802.3dj D1.4

Comment Resolution

Common Track

Matt Brown (Alphawave Semi), 802.3dj Chief Editor
Adee Ran (Cisco), 802.3dj Electrical Track Lead Editor
Mike Dudek (Marvell)

Pattern generation and encoding in PMA or Clause 177 Inner FEC intent (background, not proposal)

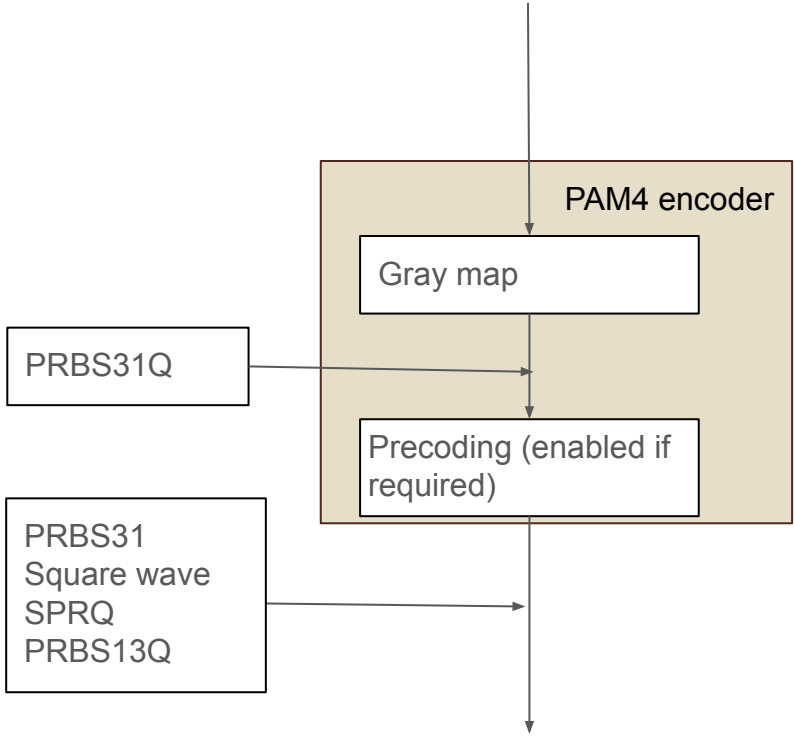
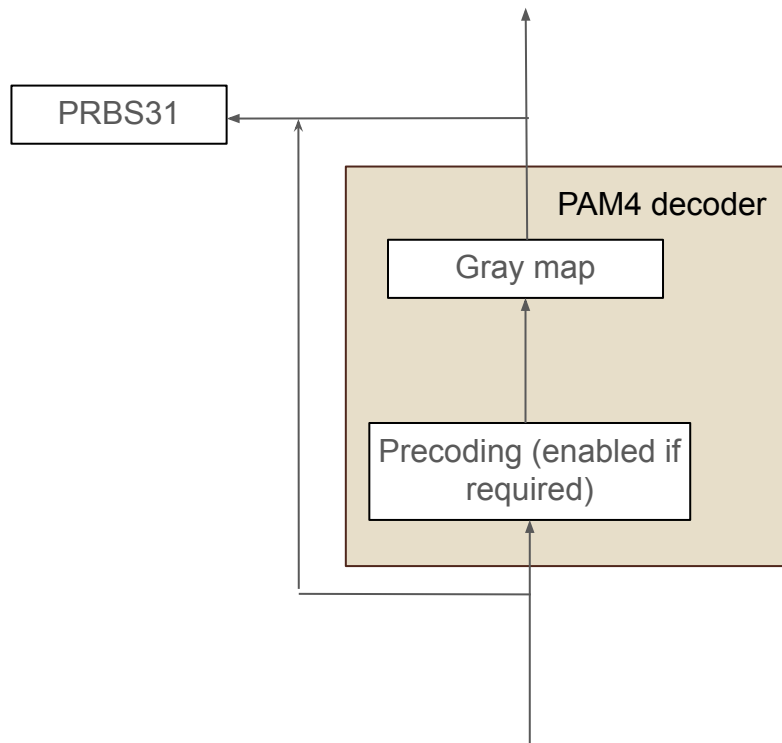
PROPOSED

ALTERNATE

Pattern checking and encoding on PMA or Clause 177 Inner FEC intent (background, not proposal)

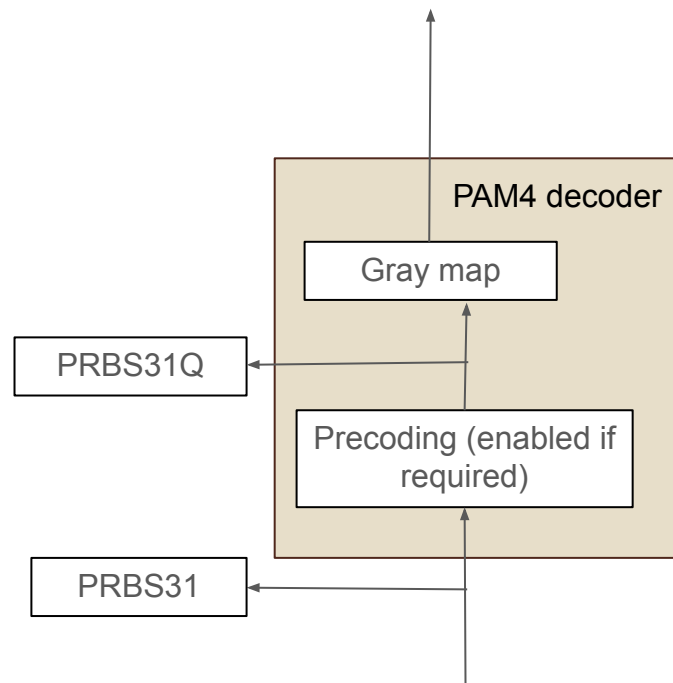
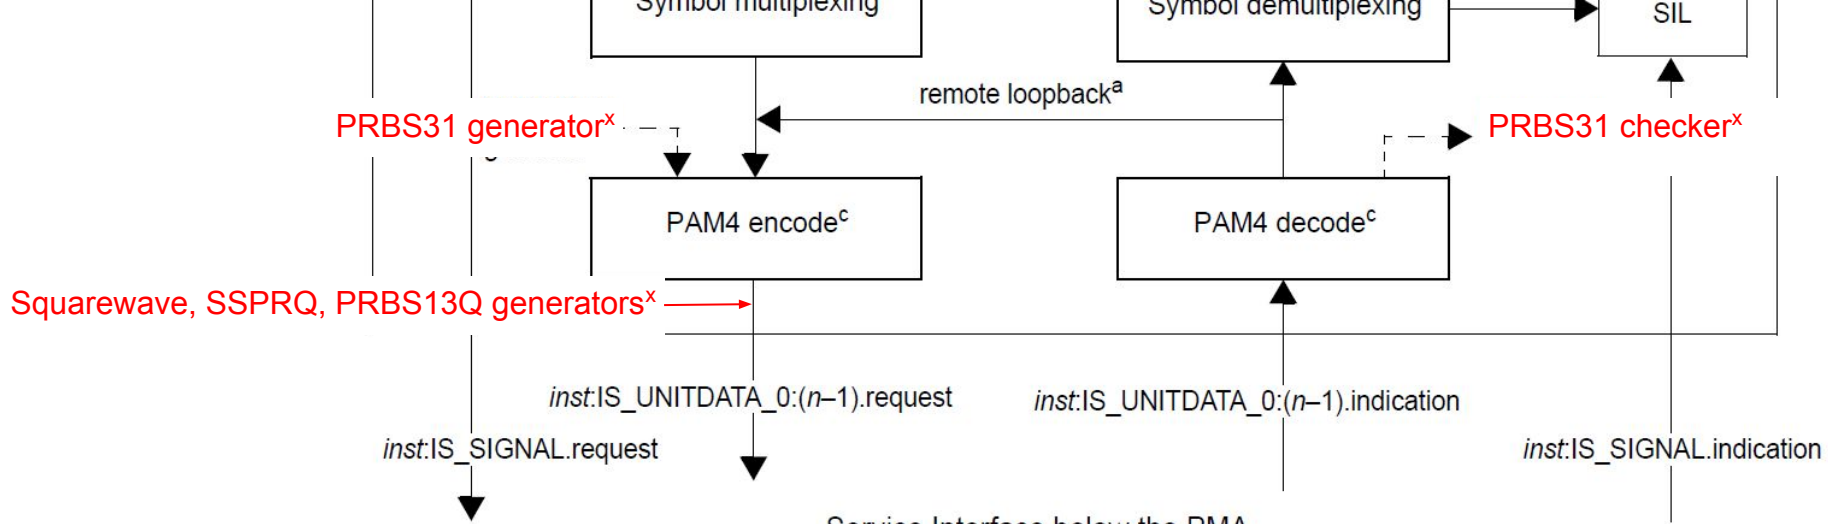
PROPOSED

ALTERNATE

Changes to block diagrams in Clause 176.

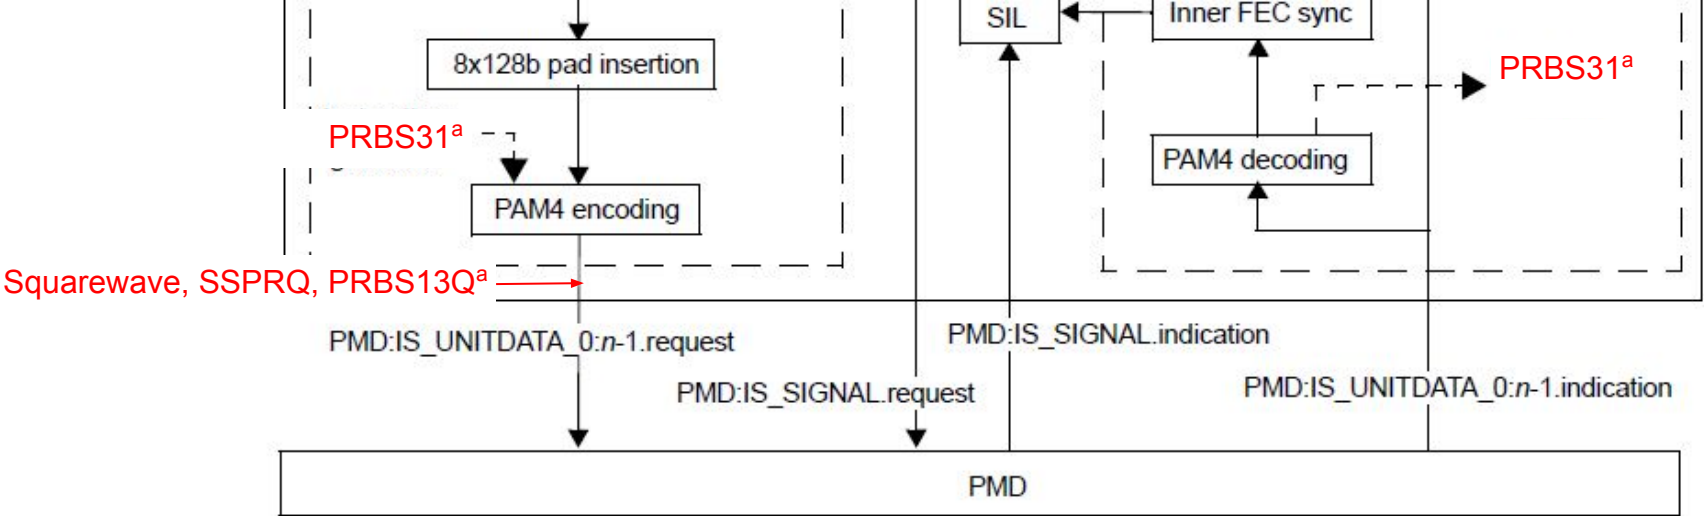
- inst*: PMA or PMD or FEC or AUI
- SIL: Signal indication logic
- ^a Optional
- ^b If 200GBASE-R, 400GBASE-R or 800GBASE-R
- ^c If the sublayer below the PMA is an AUI or PMD
- ^d If the sublayer above the PMA is a 1.6TAUI-16
- ^e If the sublayer above the PMA is an 800GBASE-R BM-PMA
- ^f PMA:IS SIGNAL.request is not present when the sublayer above the PMA is a PCS or DTE XS
- ^x Optional, required, or not applicable per <reference to table/text>
- m* = 8 (200GBASE-R), 16 (400GBASE-R), 32 (800GBASE-R), or 16 (1.6TBASE-R)
- n* = 1 (200GBASE-R), 2 (400GBASE-R), 4 (800GBASE-R), or 8 (1.6TBASE-R)

Figure 176–2—200GBASE-R 8:1, 400GBASE-R 16:2, 800GBASE-R 32:4, 1.6TBASE-R 16:8 PMAs functional block diagram
